Amendment No. 4
to the
University Commons Specific Plan
SP 18-0004 (Formerly SP 90-22)

University Commons Specific Plan
Amendment Number 3
SP 90-22 (03M)
Administrative Changes and Errata to the Final Document
Approved by the City Council on August 12, 2003
Amended by Propositions F and G on March 2, 2004

University Commons Specific Plan
Amendment Number 4
SP 18-0004
Administrative Changes and Errata to the Final Document
Approved by the City Council on XXXX XX, 2019

Figure 7
Land Use Plan
Amendment No. 4
(Administrative Change)

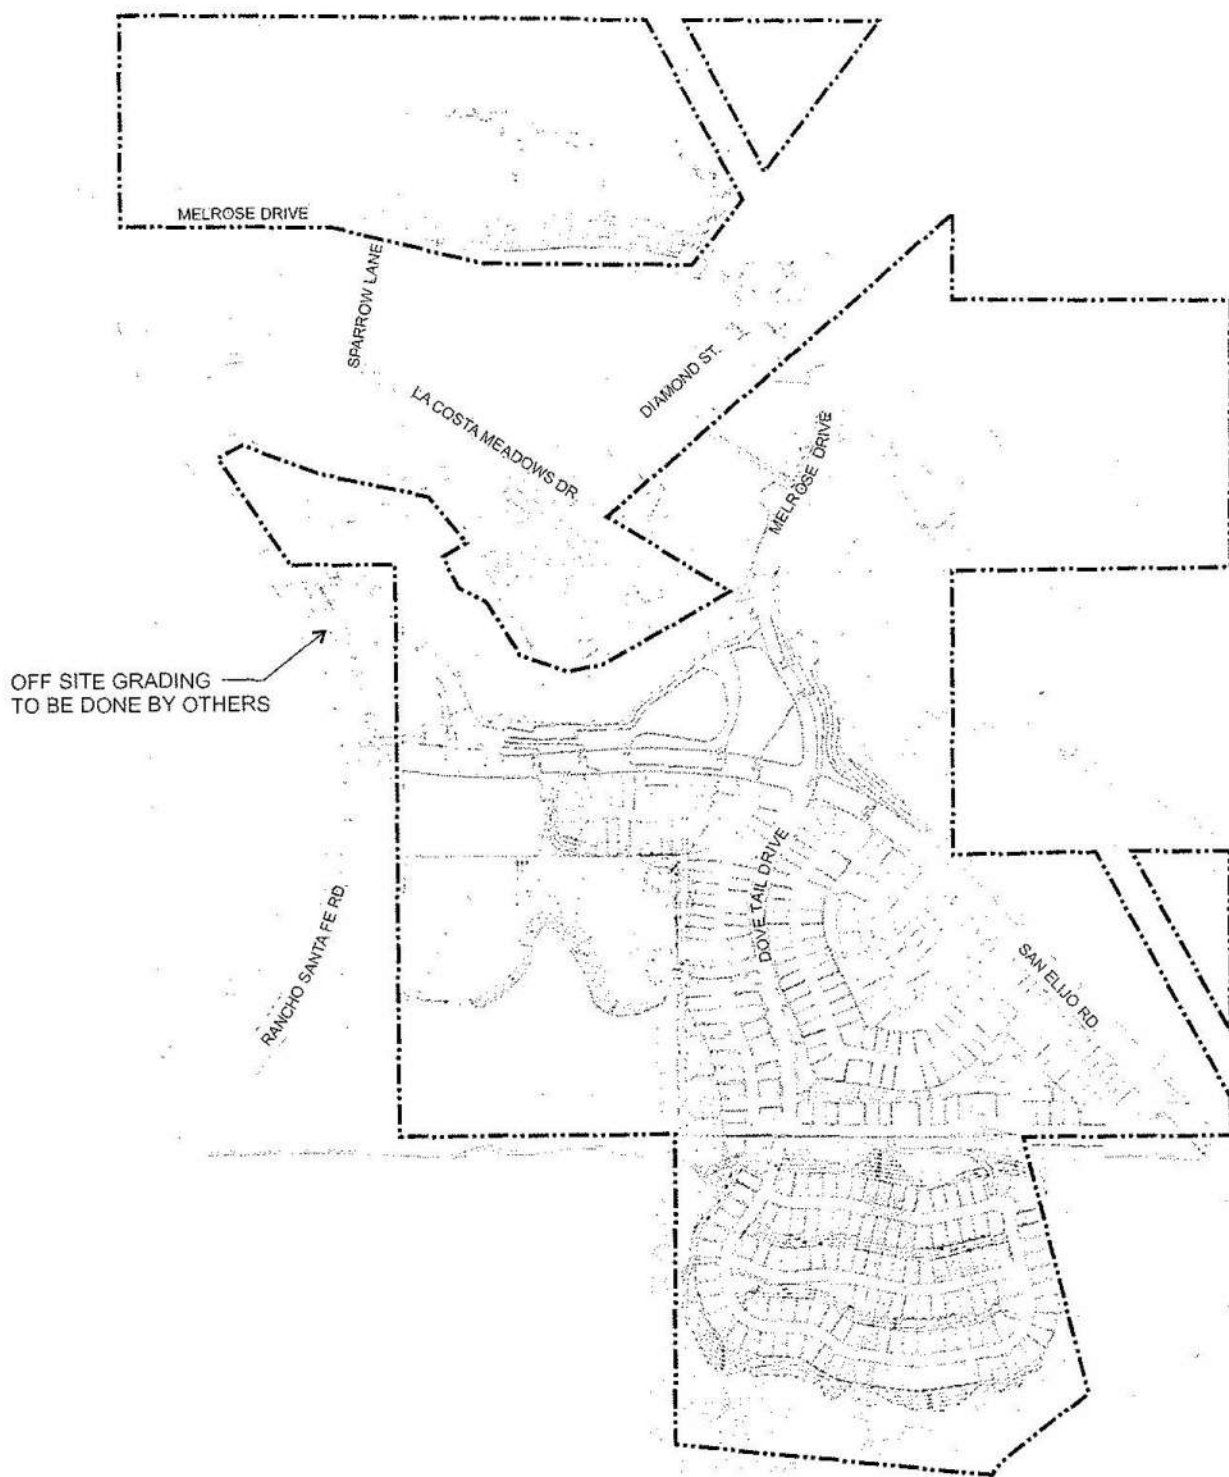
- 1. The Land Use Plan is revised to change Planning Area 4 from Light Industrial to Senior Residential (SR) and is intended to supersede and replace the Land Use Plans contained in this document. Revisions were made to Figure 4 & 7, Table 1, Sections II-B, III-C, & III-L.**
- 2. Permitted architectural styles are expanded to include the SR zoning. Permitted zoning standards and regulations are expanded to include development within the SR zone.**
